SUBJECT: CATAWBA NUCLEAR STATION, UNIT 2 RE: COLD LEG ELBOW TAP FLOW
COEFFICIENTS

SUPPLEMENT TO SAFETY EVALUATION
BY THE OFFICE OF NUCLEAR REACTOR REGULATION
DETERMINATION OF REACTOR COOLANT SYSTEM FLOW RATE FROM A
CALORIMETRIC HEAT BALANCE ON THE SECONDARY SYSTEM
DUKE ENERGY CORPORATION
CATAWBA NUCLEAR STATION, UNIT 2
DOCKET NO. 50-414

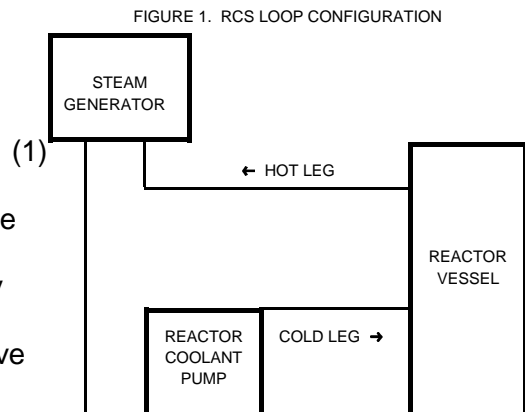
The RCS configuration illustrated in Figure 1 is typically used as a basis for flow rate analyses. An overall heat balance is taken over the control volume defined by the surface of the RCS to obtain Equation 1:

FIGURE 2. THERMODYNAMIC ANALYSIS OF RCS

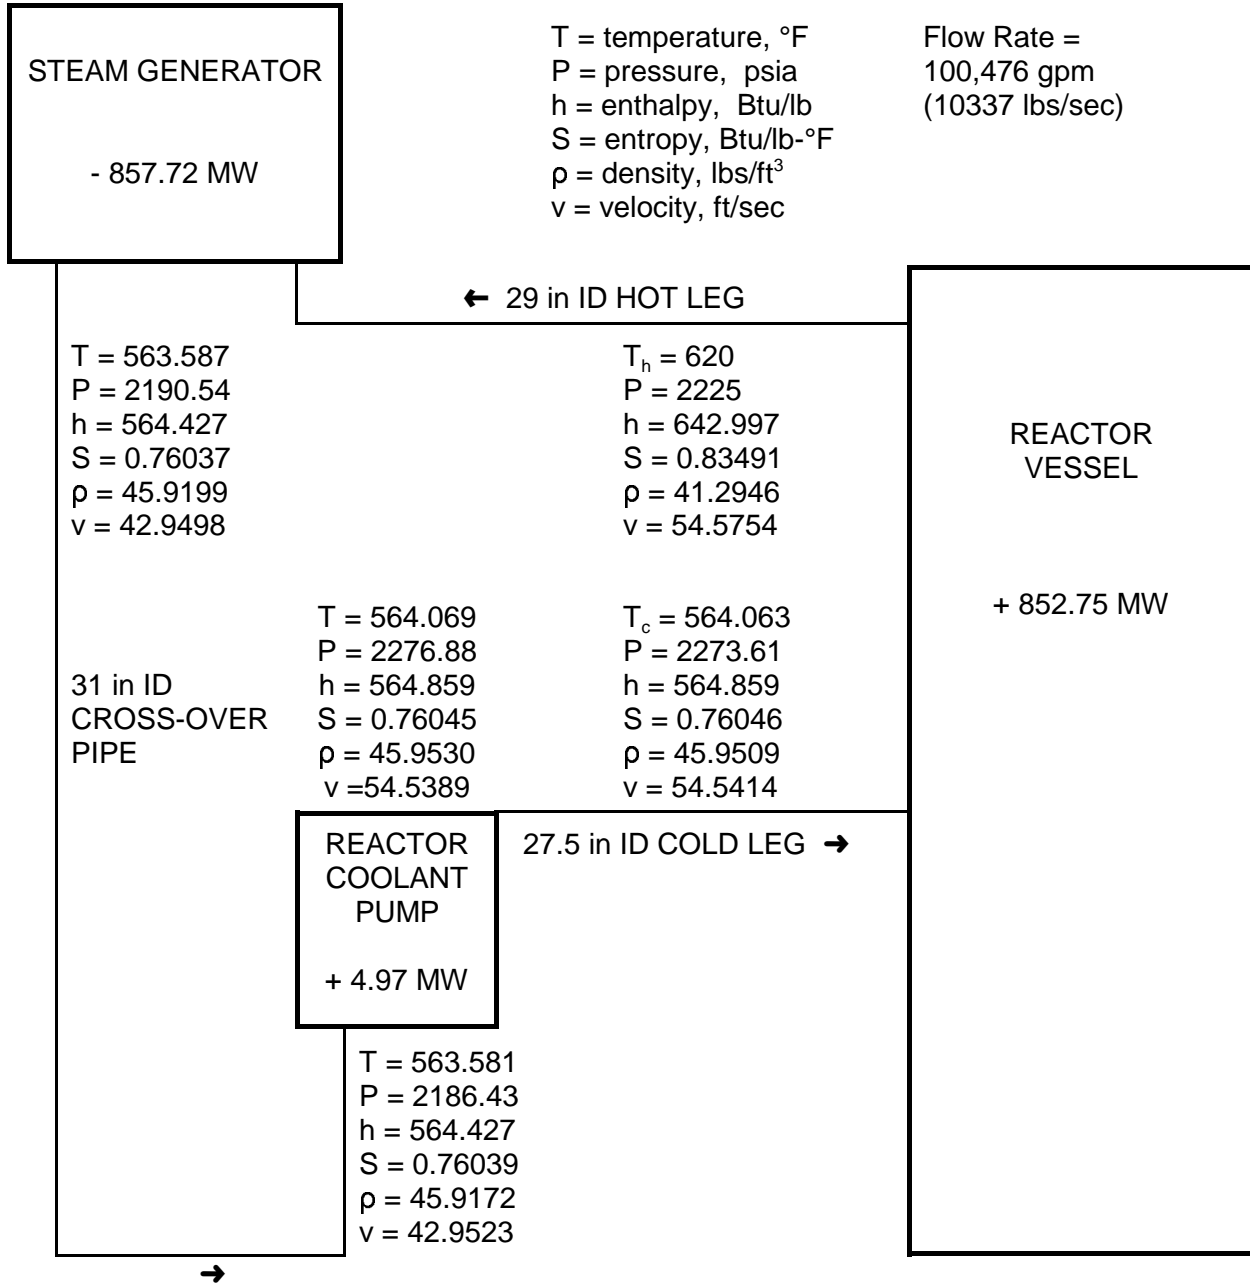
The results are summarized in Figure 2. The results demonstrate that v_c and v_h are essentially equal, confirming the assumption used to obtain Equation 8.³ Note that this is not true for flow

The Figure 2 results refute the generally accepted conclusion that in a flowing system with a viscous fluid, frictional pressure drop causes the fluid temperature to increase, as assumed in Equation 4. The reverse behavior is illustrated in Figure 2 where, for example, temperature decreases from 563.587 °F at the SG outlet to 563.581 °F at the RCP inlet.

FIGURE 3. RCS BEHAVIOR AT LOW PRESSURE

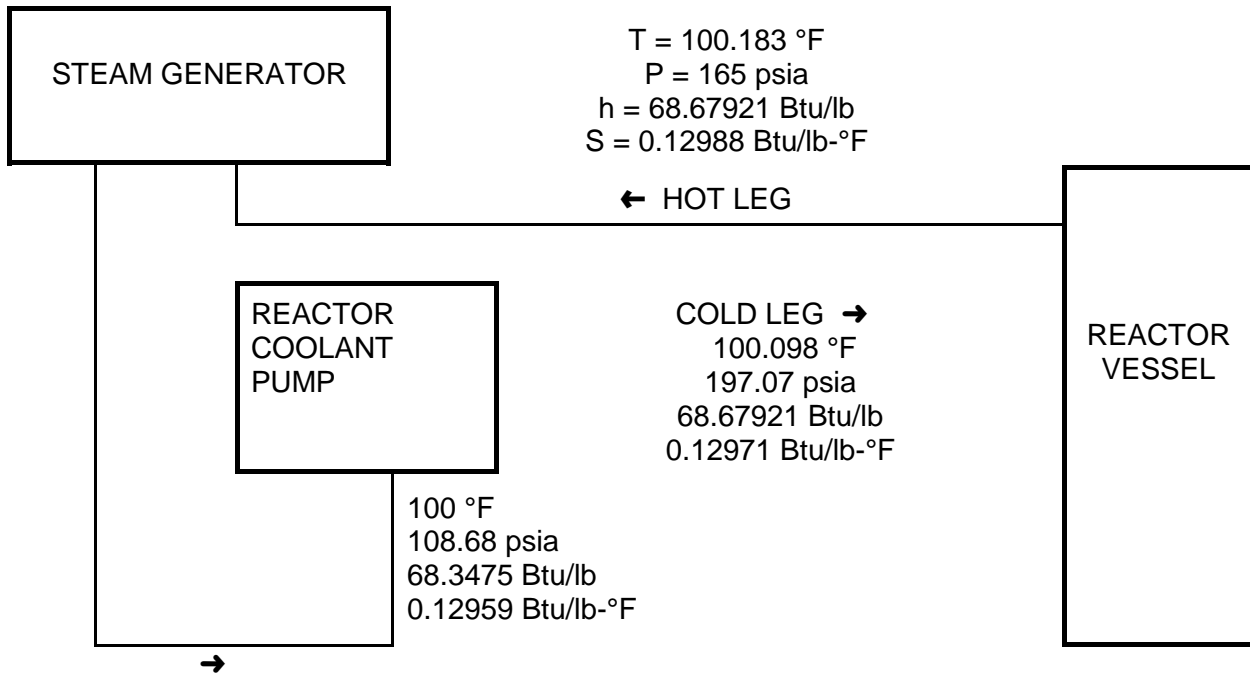
To address this apparent anomaly, consider the calculation results summarized in Figure 3 for conditions at roughly 100 psia and 100 °F with the additional assumption of no core heat addition. In this case, the temperature increases from $T_c = 100.098$ °F to $T_h = 100.183$ °F, as intuitively expected.

The NRC staff concludes that a thermodynamically based calculation yields the expected temperature behavior when temperature and pressure are relatively low, but the reverse occurs at typical RCS operating conditions. Such behavior is typical of the Joule-Thomson throttling process where $\Delta h = 0$. The behavior is described by the Joule-Thomson coefficient:
